There are three causes for complaints such as "distorted," "fuzzy" or "noisy" reproduction when playing records on the Model 296.

The first production models of the 296 and 296-A will use a low impedance type pick-up, Part No. 4144, with a coupling transformer, Part No. 4145. The standard Philco pick-up will not be used for the first few weeks.

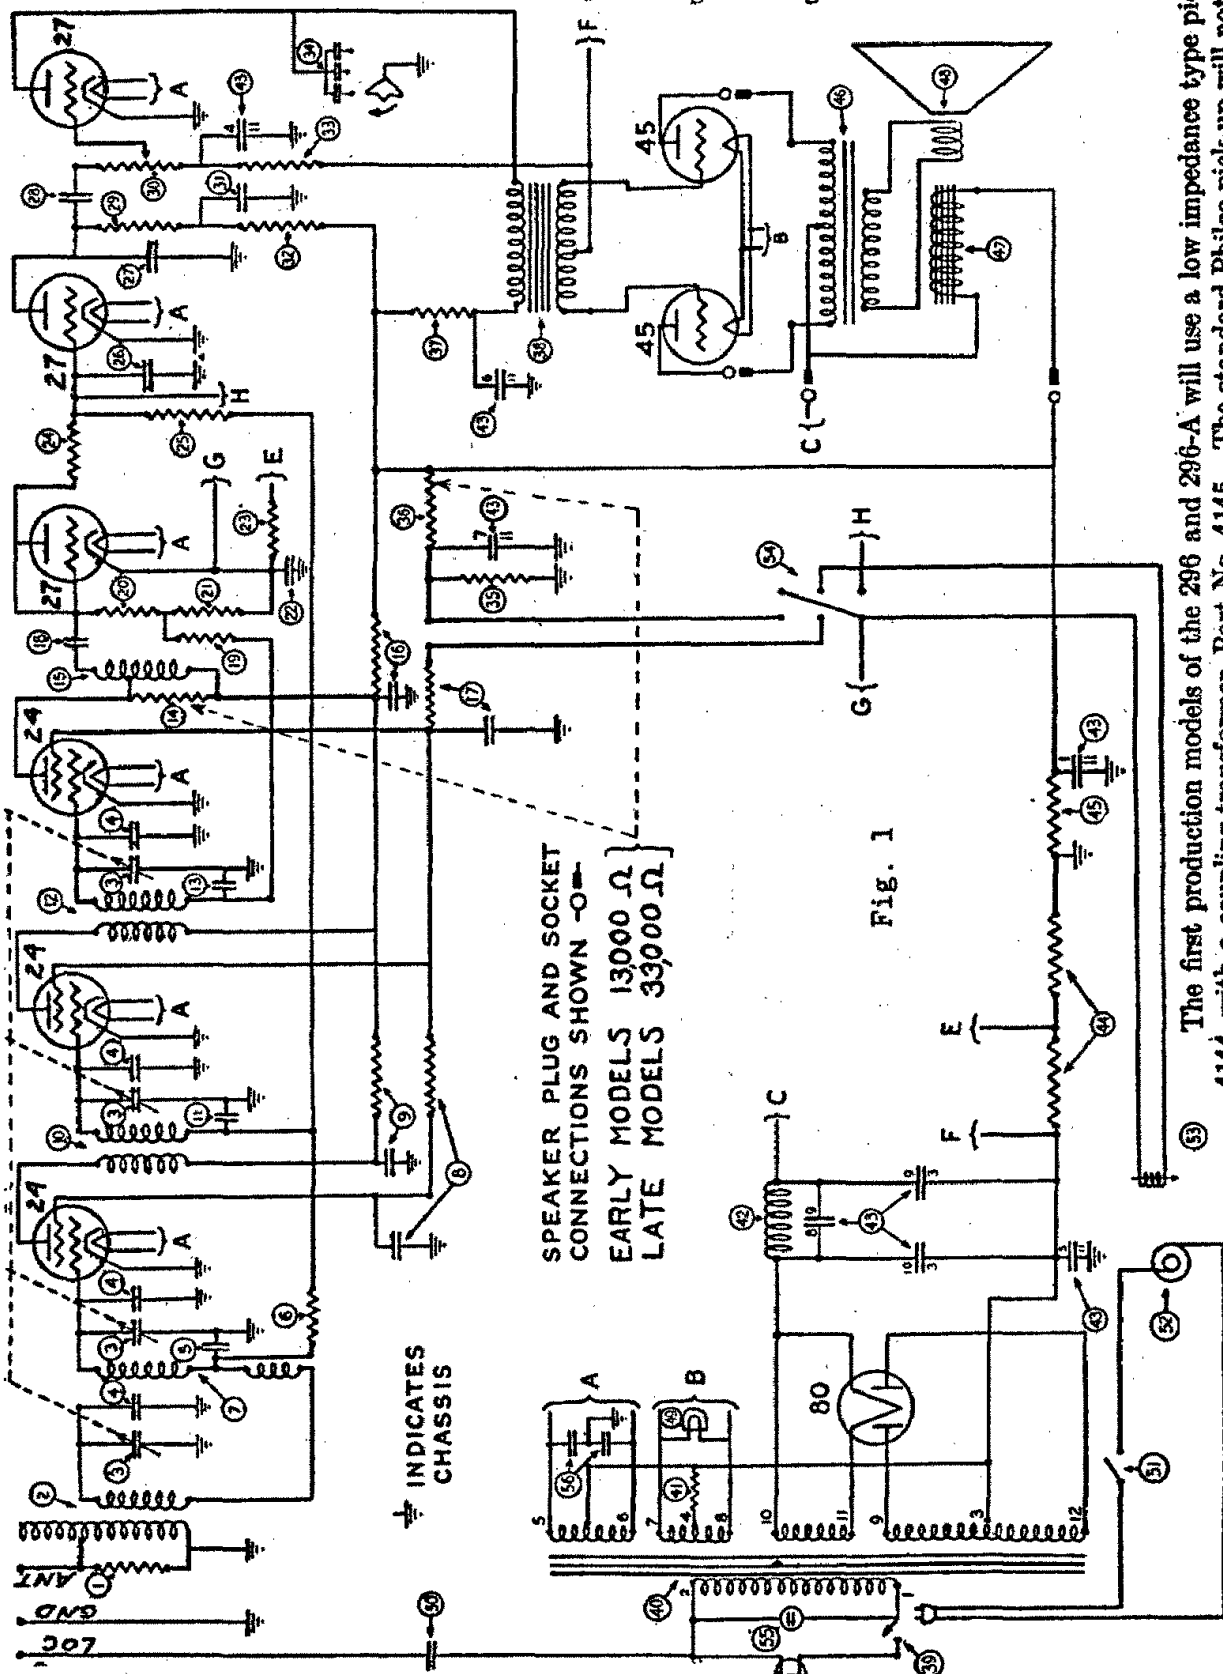
A heater by-pass condenser has been added to the 296 and 296-A chassis. The number in Fig. 1 is 66 and the part number is 3557. This condenser prevents any tendency of the Receiver to oscillate, which may have been noticed on the first few Radio-Phonograph Receivers.
